***RAC* RESPONSES TO PEER REVIEWER COMMENTS**

Task 5: Independent Calculation

Radionuclide Soil Action Level Oversight Panel

TASK 5: INDEPENDENT CALCULATION RESPONSES TO COMMENTS ON DRAFT REPORT

Figure 1. The maximum all pathway dose for plutonium isotopes as a function of the plutonium K_d value. Doses increase with the K_d value because higher K_d values result in lower leaching and greater activity retained in the surface soil.

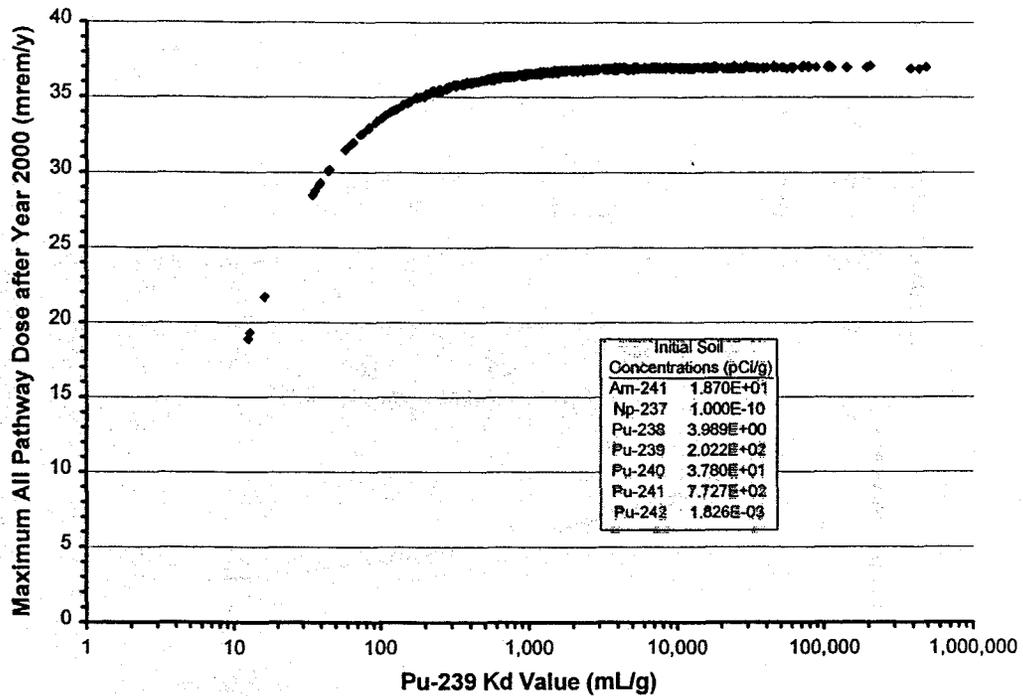
20. In Appendix D, a Pu K_d of 5350 ml g^{-1} is used, while on p. 3-1, a value of 2000 is assumed. Should these values be consistent?

The maximum total dose is relatively insensitive to the plutonium K_d value for K_d values greater than ~ 1000 mL g^{-1} . Therefore, it makes little difference whether we used a K_d value of 2000, 2300, or 5350 mL g^{-1} . The purpose of the Figure 3-1 and Appendix D was to simply illustrate decay and ingrowth in soil and the relationship between total dose and time respectively. The figure below (Figure 1) shows the relationship between the maximum total dose after the year 2000 and the plutonium K_d value. The graph was generated using 500 RESRAD trials and holding all other model parameters constant. Plutonium K_d values were sampled from a distribution having a geometric mean of 2300 mL g^{-1} and a geometric standard deviation of 5.6. Maximum doses were achieved before the year 2100 in all cases and doses were driven by soil and plant ingestion. Higher soil K_d values result in longer soil residence times. Longer soil residence times allow for greater ingrowth of radioactive progeny and lead to higher doses.

Figure 3. Regression of the percent of total plutonium inventory in the 0–3-cm soil layer as a function of time. The year in parenthesis was the year sampling took place. Data were obtained from the summary provided in Webb (1996).

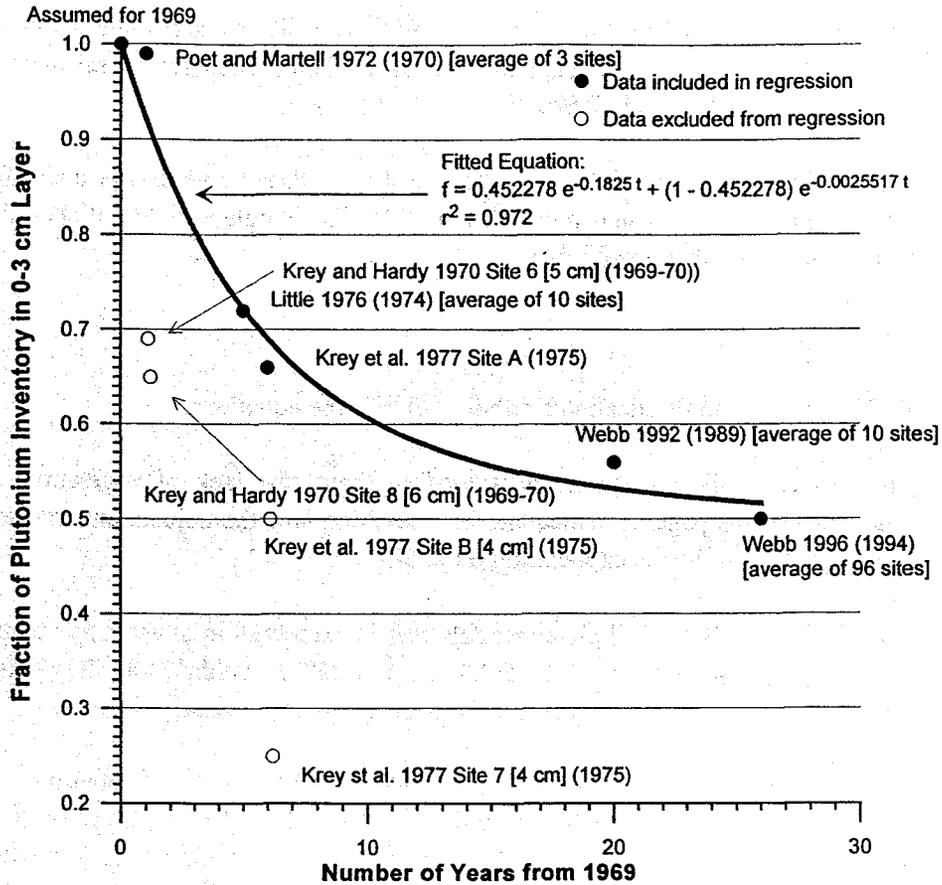
18. Page 4-3, Figure 4-1. I have several points. First, having some historical familiarity with the Poet and Martell work and the subsequent debate, I agree with the choices of the data chosen for use in the regression, and also the choice of data to be omitted. Second, the dashed line (the "separate analysis") clutters up the figure. Can the same confirmation be presented in another way, perhaps in the text? Third, why doesn't the shaded triangle extend out to capture the Webb 1996 data point? Finally, in the legend, does the last sentence imply that there is a 15% probability that the rate might be zero or even positive, that is, that plutonium might have been *accumulating* in the top 3 centimeters? I suggest you drop this last sentence altogether.

To provide additional support for our choice of data used in the regression, we have identified the number of sampling sites that define each point on the graph (see Figure 3). Note that the number of sites sampled by Webb and Little far outnumber the number of sites represented by Krey and others. Had the data from each individual site been readily available, it
